EARTHWORK QUALITY CONTROL OVERVIEW

AND AS-BUILT DRAWINGS

CONSTRUCTION OF STAGE I

SHOOTARING CANYON URANIUM PROJECT

Figure 1

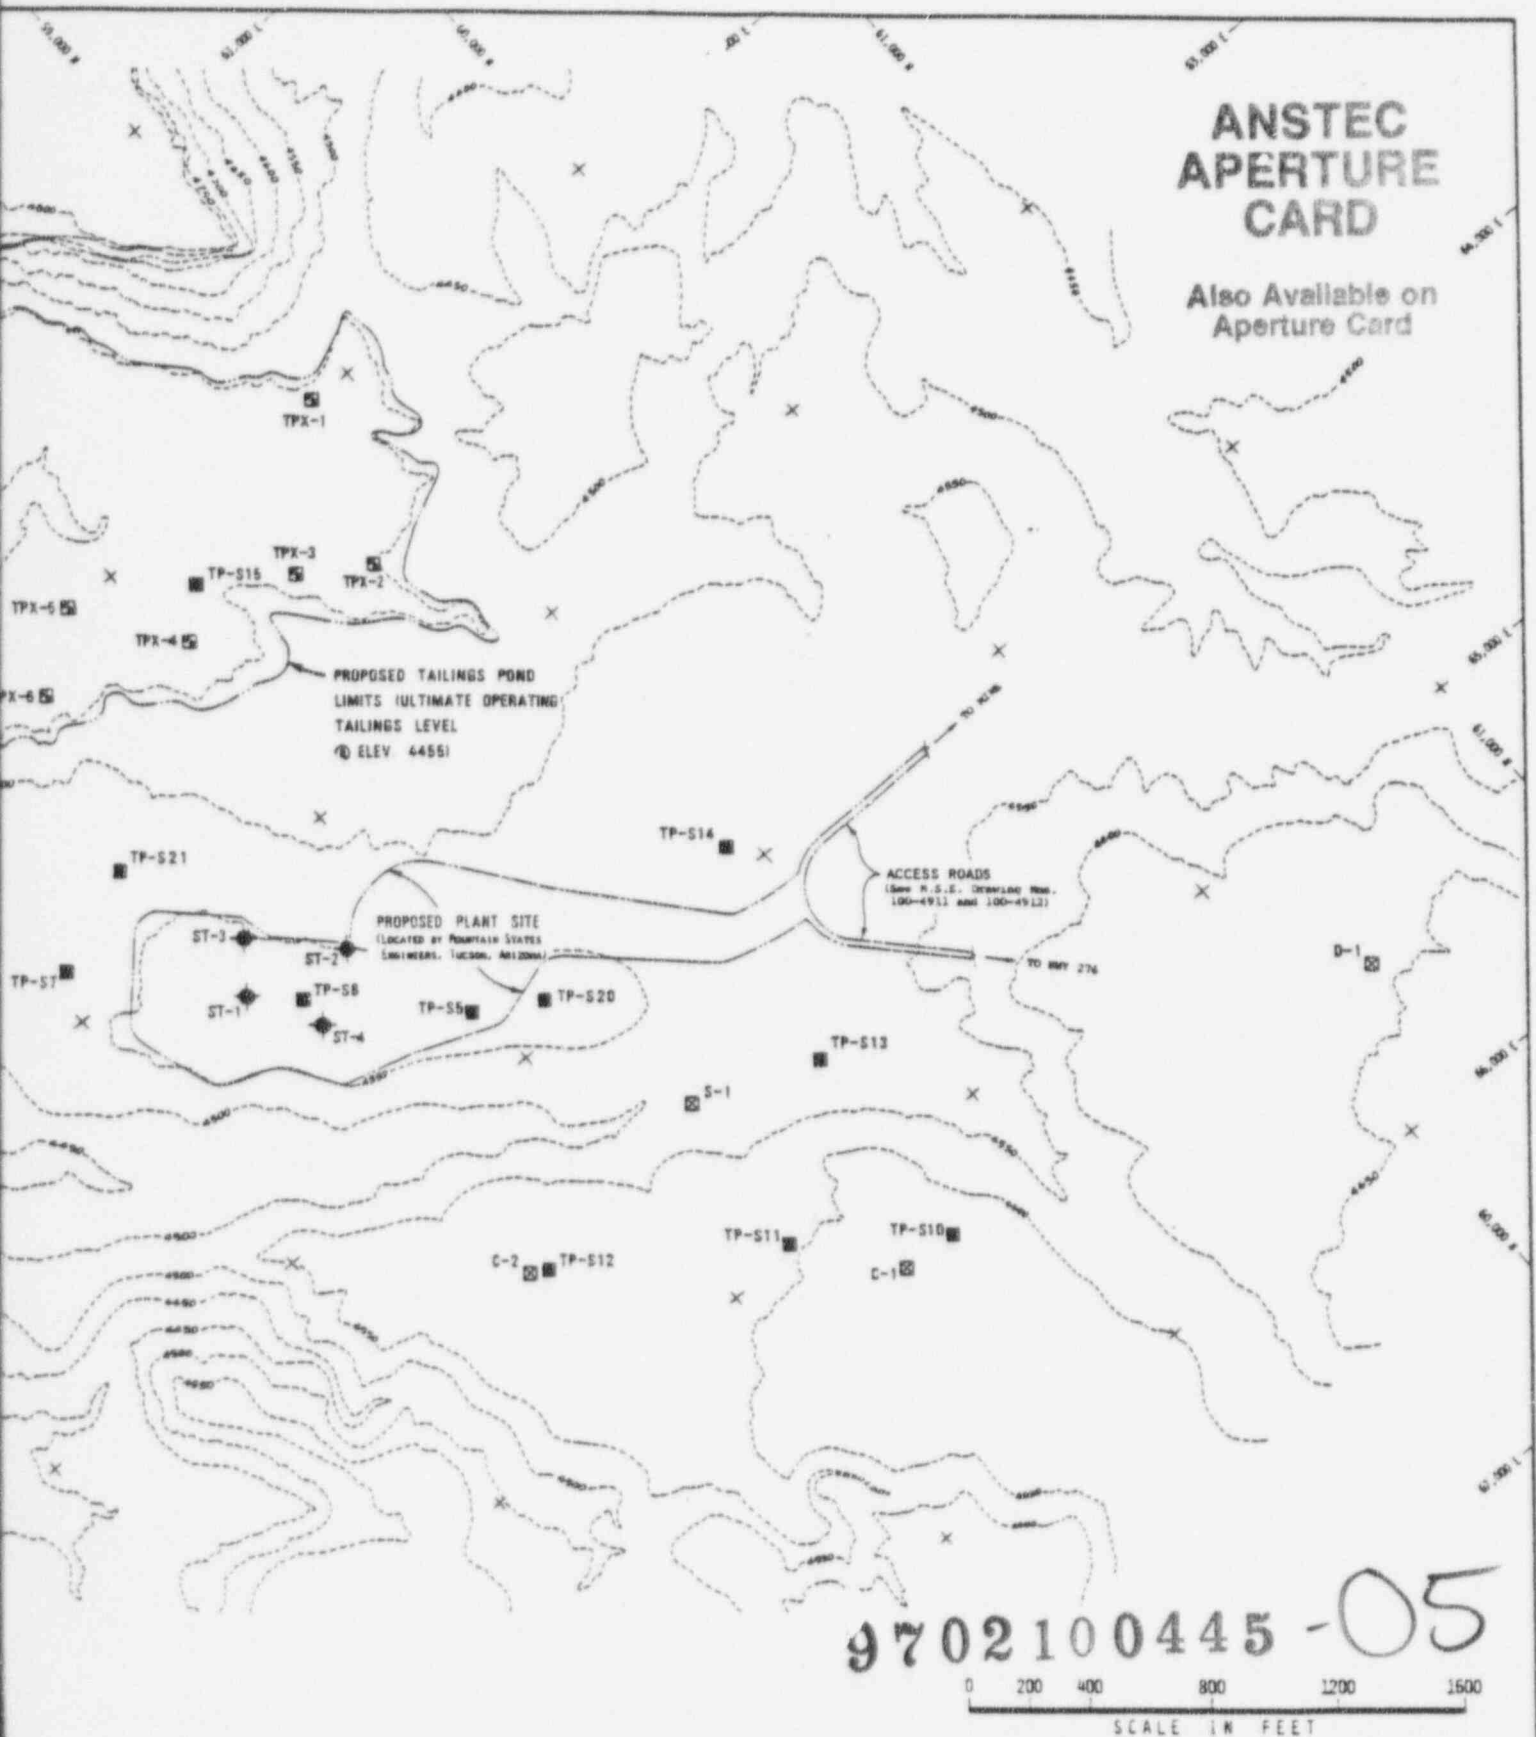
1	6-23-82	No AS-BUILT Changes	BBG
No.	DATE	REVISIONS	By
R.E. NO.	1973	APPROVED:	
DATE:	5-24-79	<i>Demetrius B. Jordan</i>

Figure 2

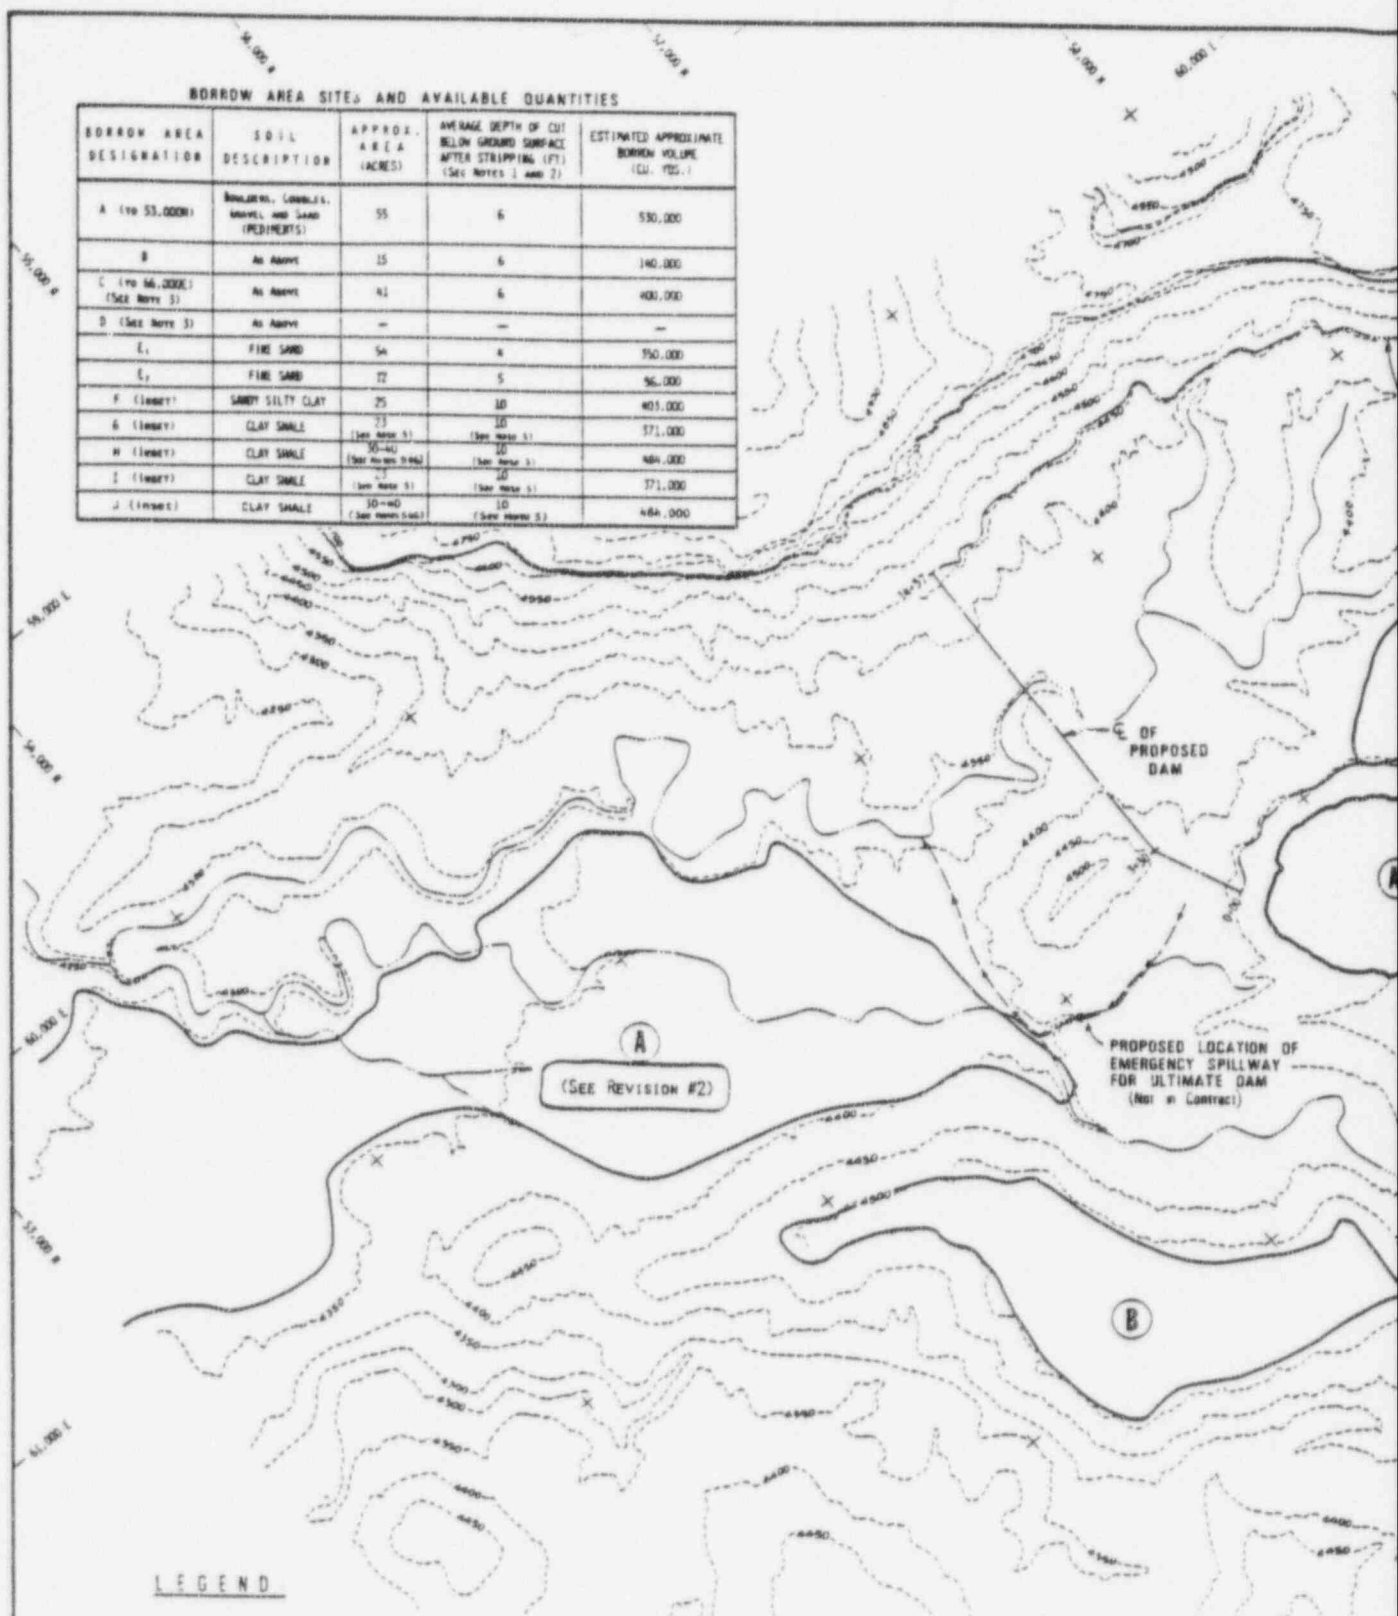
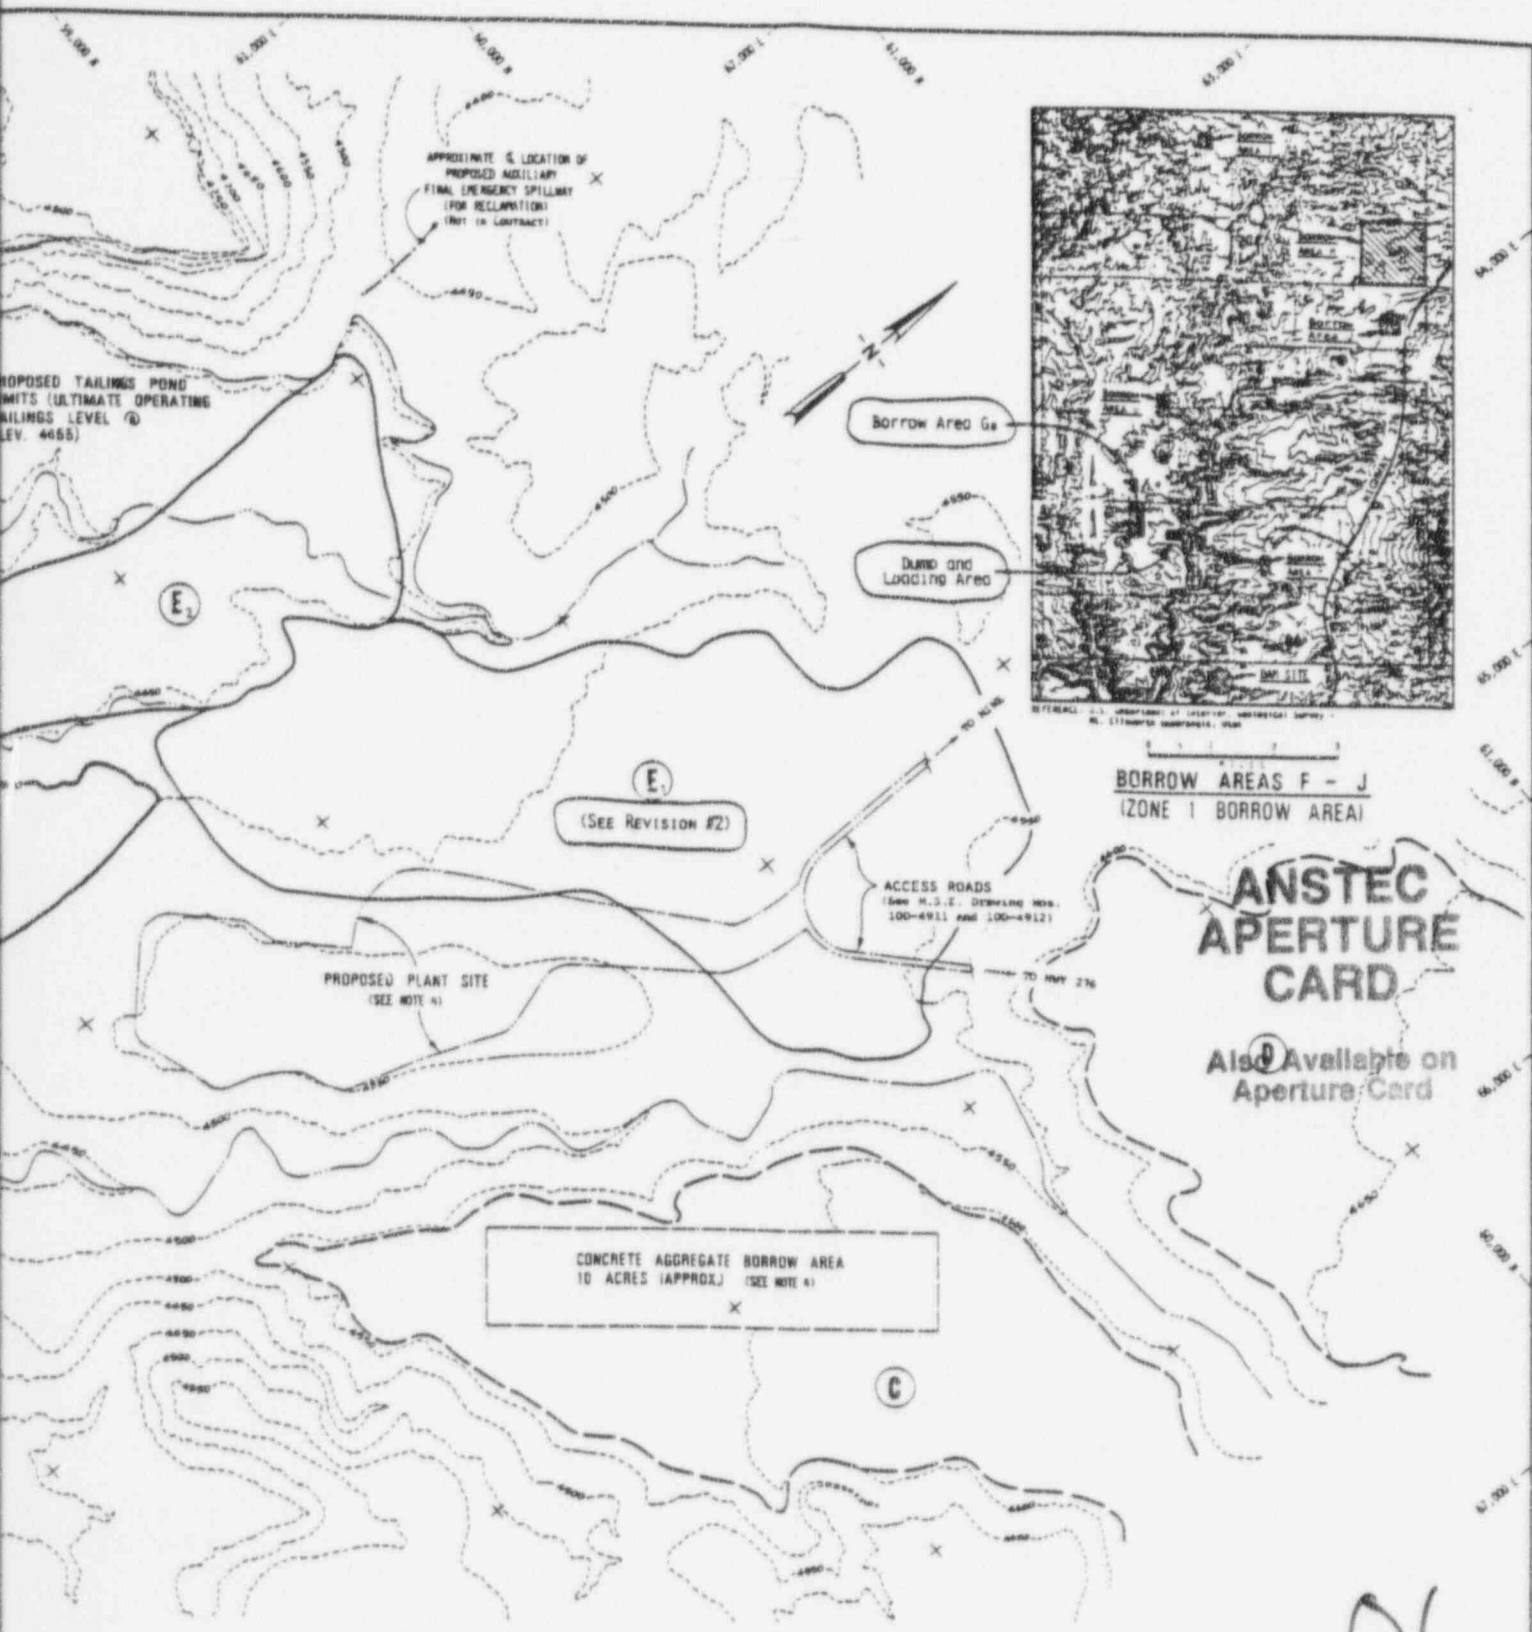
2	6-23-82	Added Borrow Area (C) to Site Map. Area was the actual source of Zone 1, Zone 2 was taken from Area (E). Zone 3 priority came from Area (A).	DRG
1	1-12-81	Addition of BORROW AREA A <sub>1</sub>	D.A.P.
REVISIONS			
NO.	DATE	REVISIONS	By
R.E. NO.	1983	APPROVED:	
DATE:	5-24-79	<i>Ronald B. Jordan</i>

Figure 3

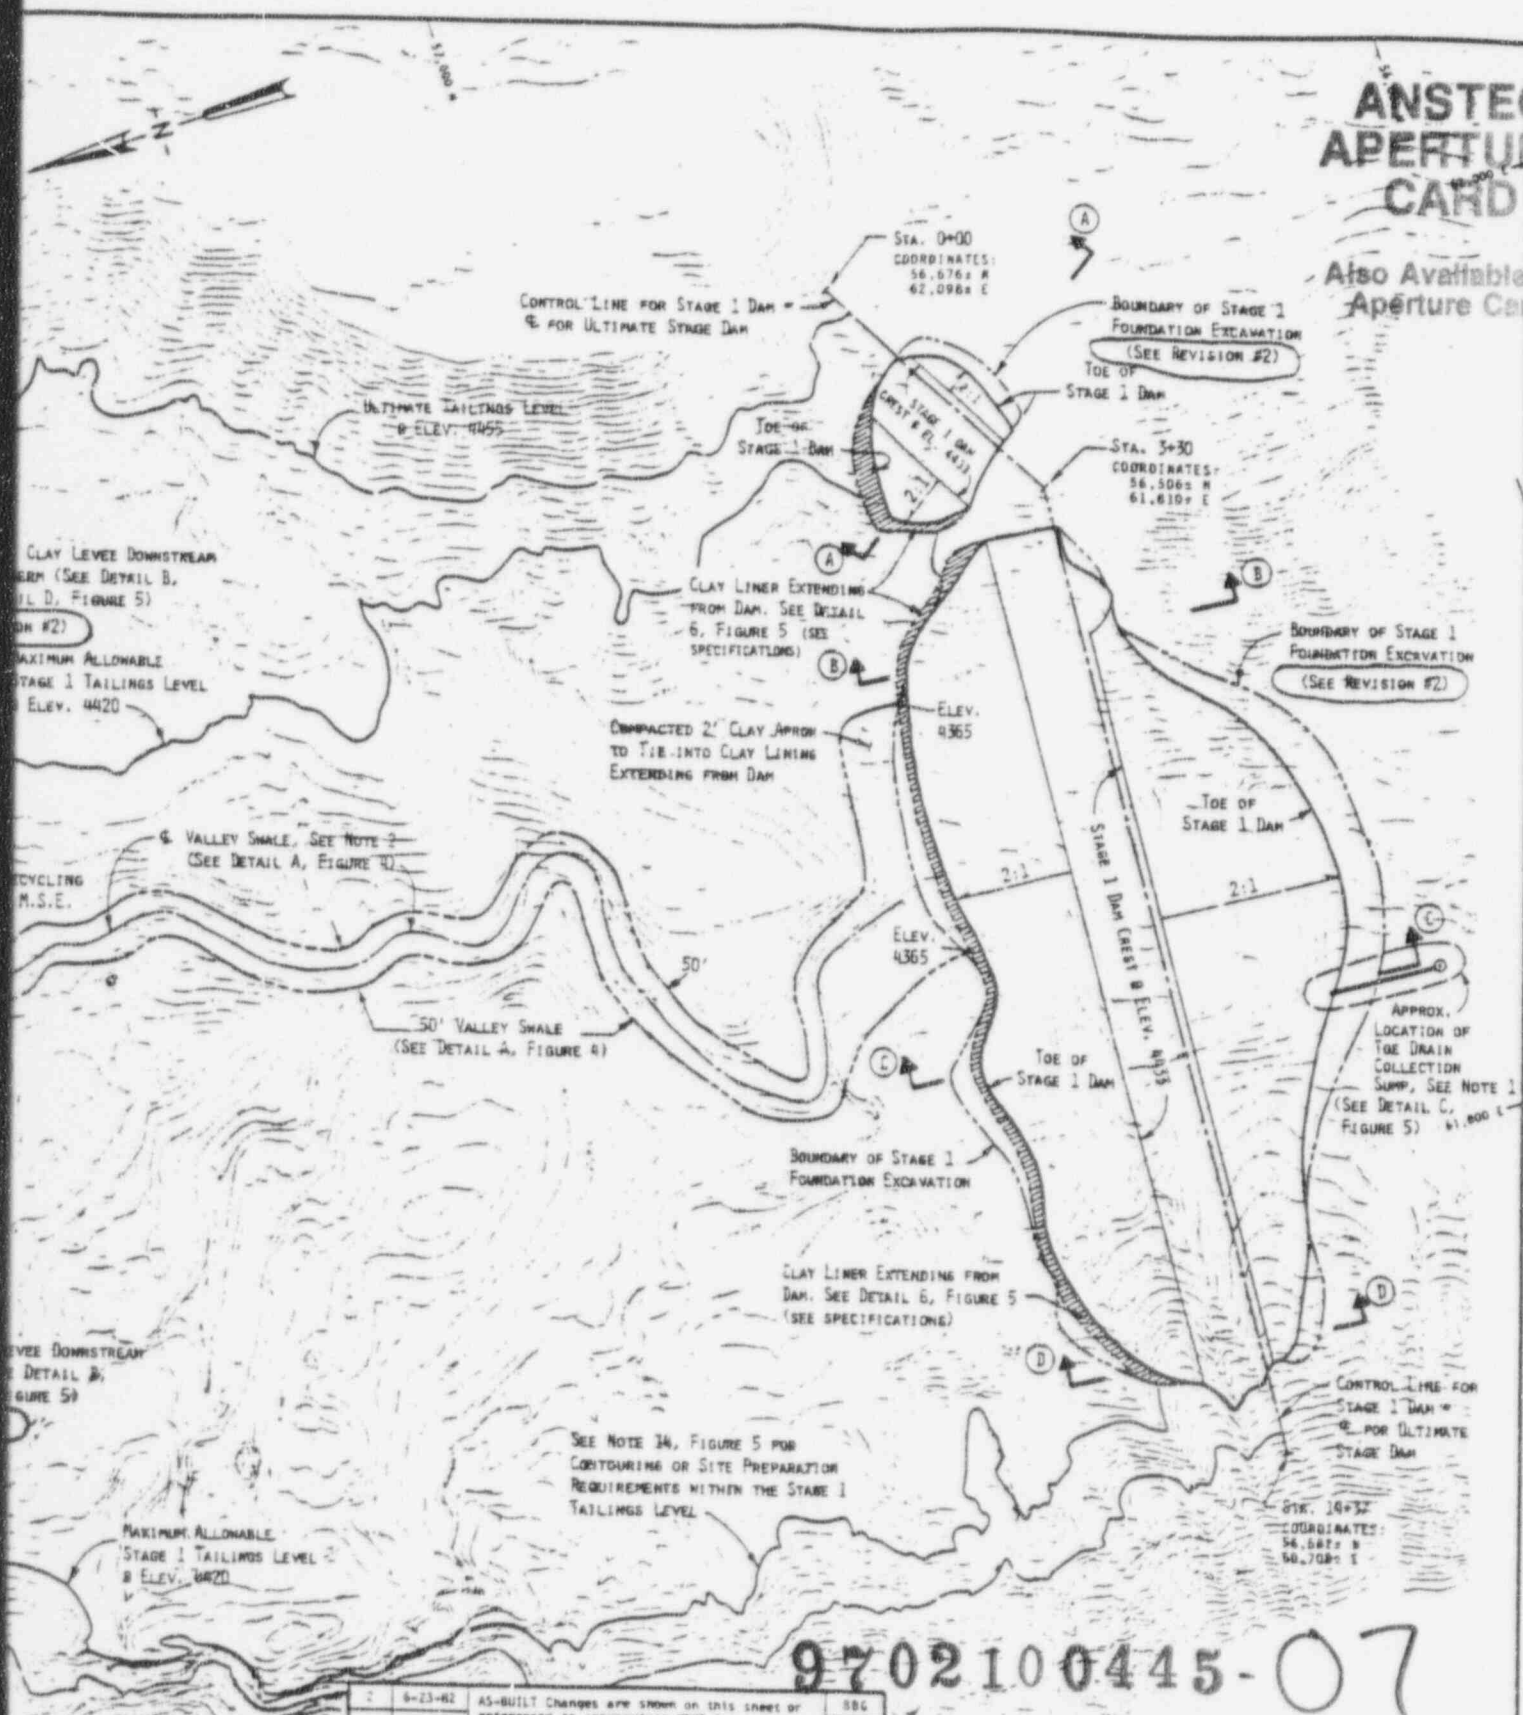
2	6-23-82	AS-BUILT Changes are shown on this sheet or referenced to appropriate MSN Drawings. These include: Drawings--- 1) Dam Area Plan and Profile; 2) Impoundment Area Topo Map, Drain Pipes and Piezometers, Cross Valley Berm and Upper Impoundment, Zone 1 Finish Grade; 3) SA, 11-58, 11-5C (As-Built Profile, A' and B' Drain Pipe Impoundment Area); 4) 6 (Typical Section - Cross Valley Berm)	886
1	6-8-80	ADDED ADDITIONAL INTERIOR (VAL. DRAIN PIPE) AND COORDINATES OF THE 11-5C (As-Built Profile)	886, 887
No.	DATE	REVISIONS	BY
R.L. NO.	1933	APPROVED:	
DATE	5-24-79	<i>Donald B. Gordon</i>
